Roundup Power Project Final Environmental Impact Statement

Montana Department of
ENVIRONMENTAL QUALITY

January 2003

Enclosed is the Final Environmental Impact Statement (EIS) for the proposed Roundup Power Project. The Final EIS adopts the Draft EIS as a part of the final, responds to public comments, and provides substantive changes, which amend the Draft EIS in response to public comments.

Figure 3-7

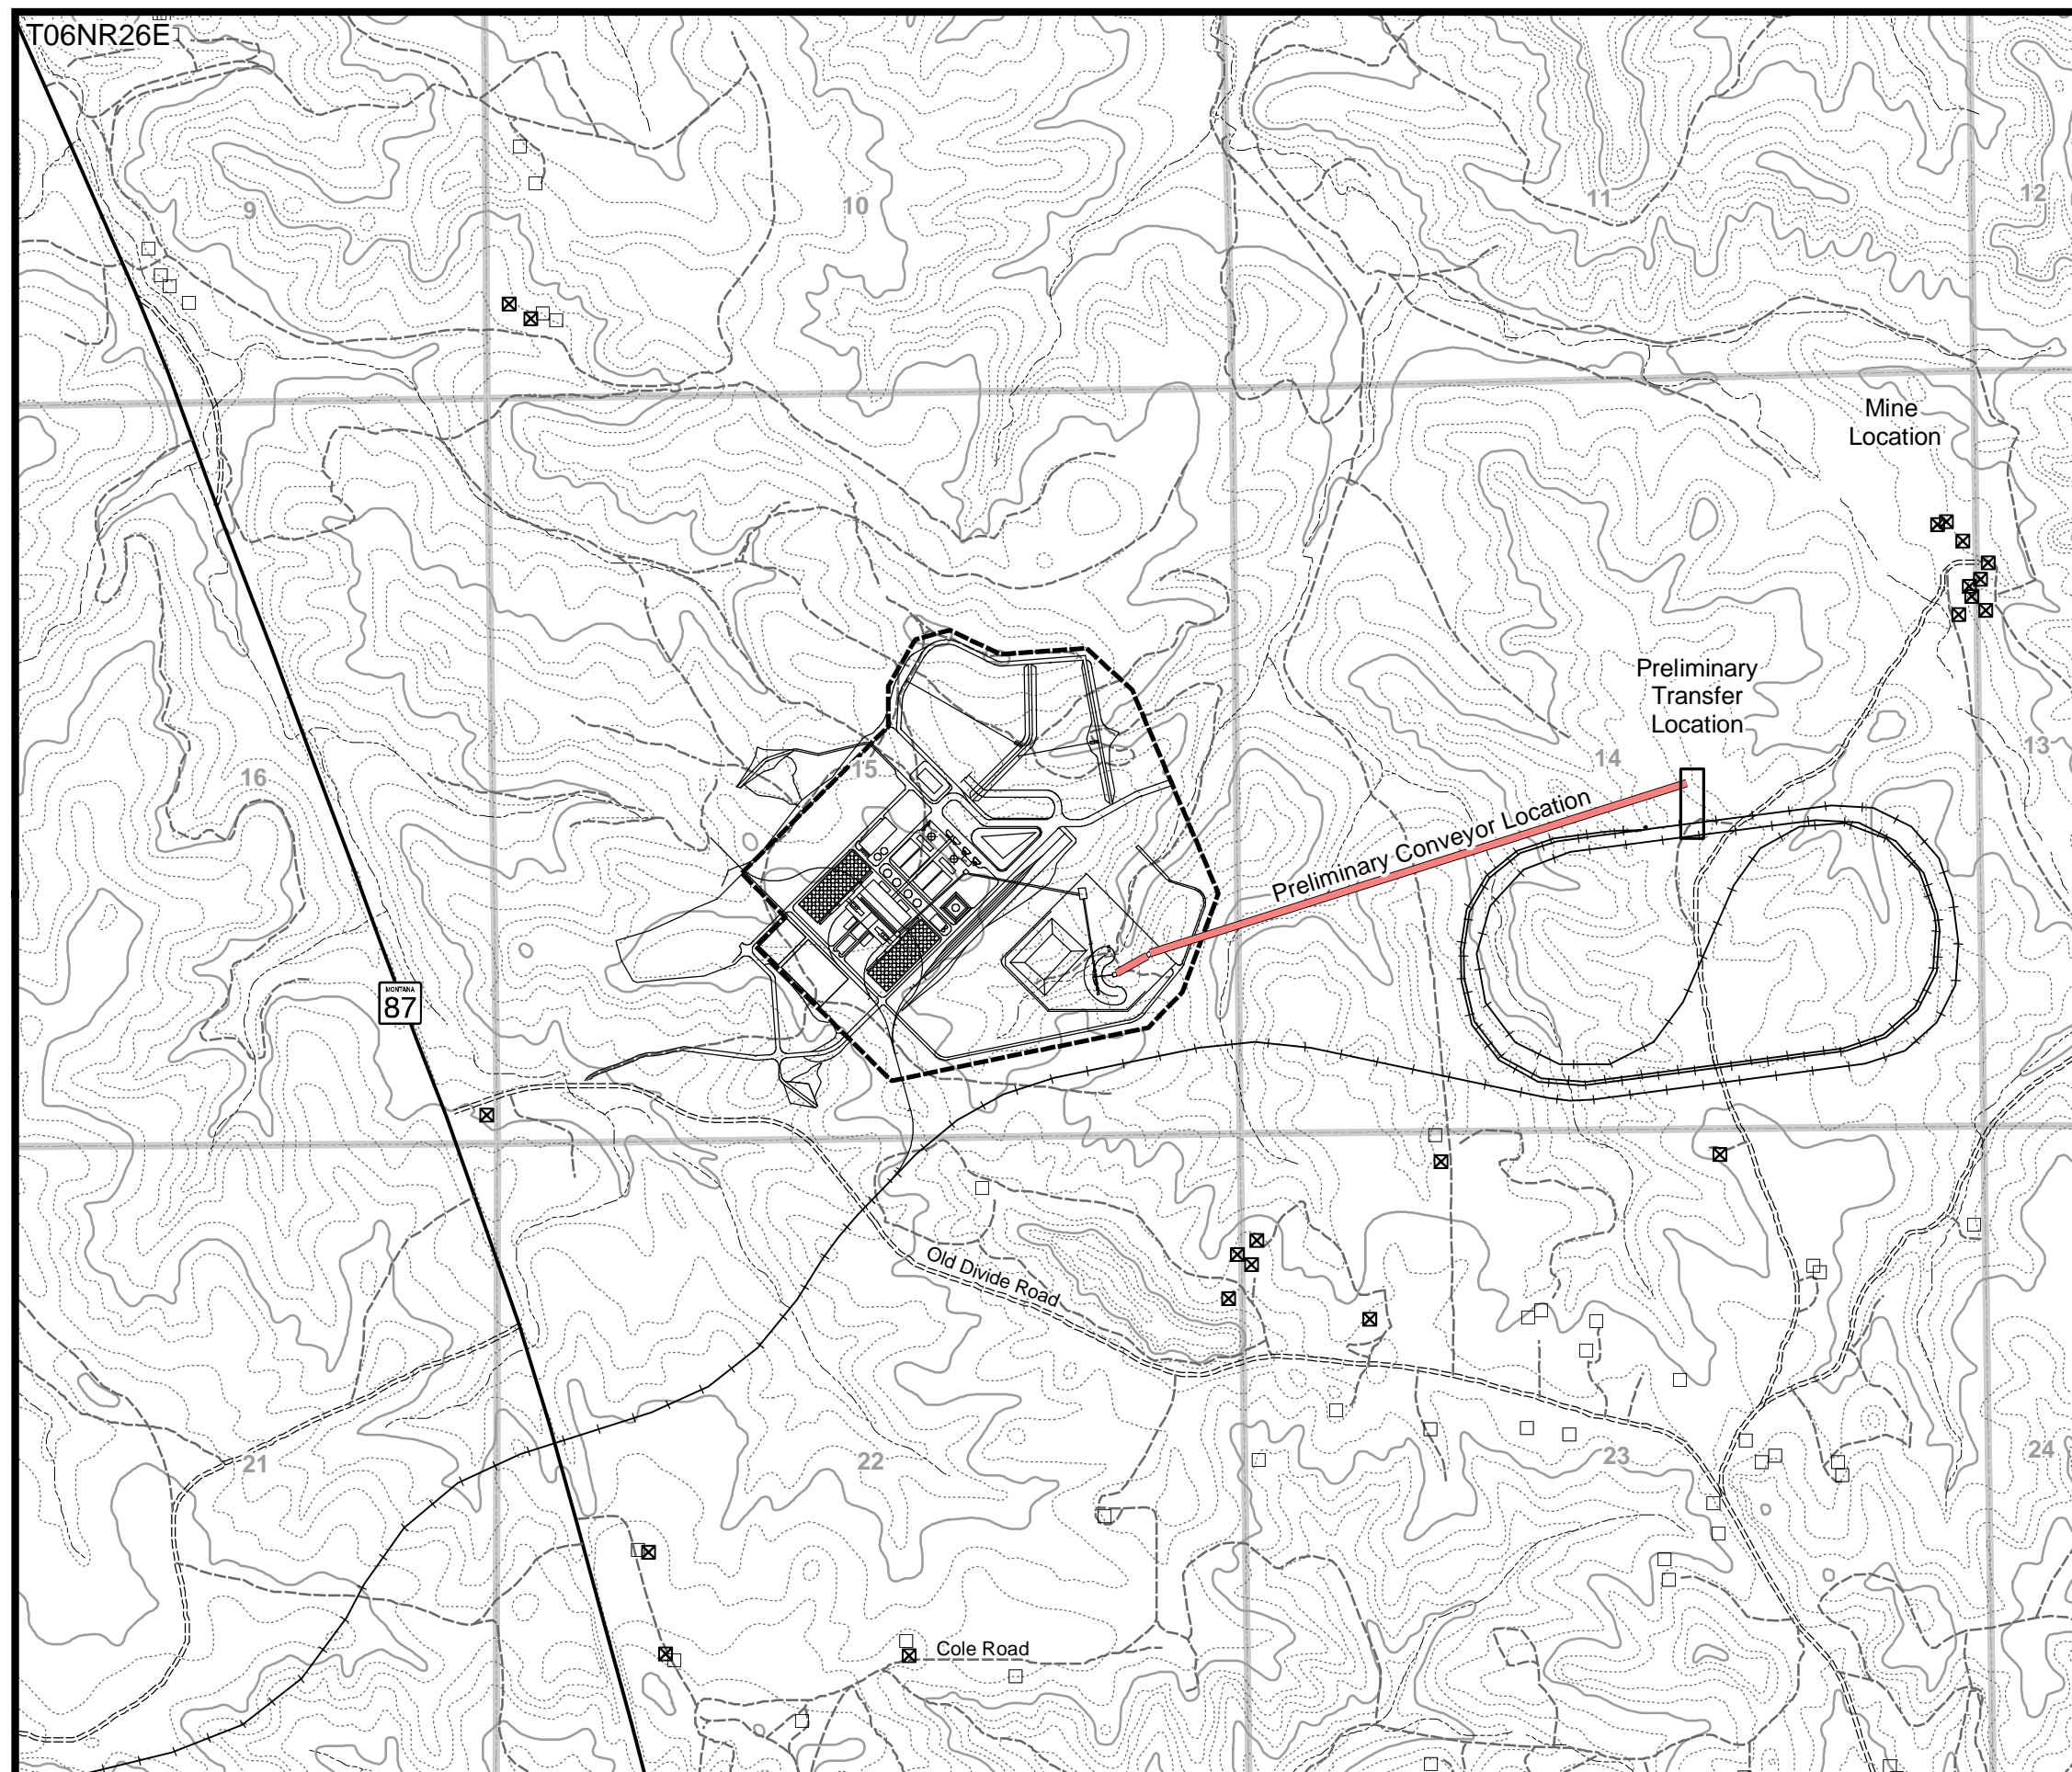
Page 3-55, Figure 3-7 Land Use, add label for Cole Road. See attached map at the end of this section.
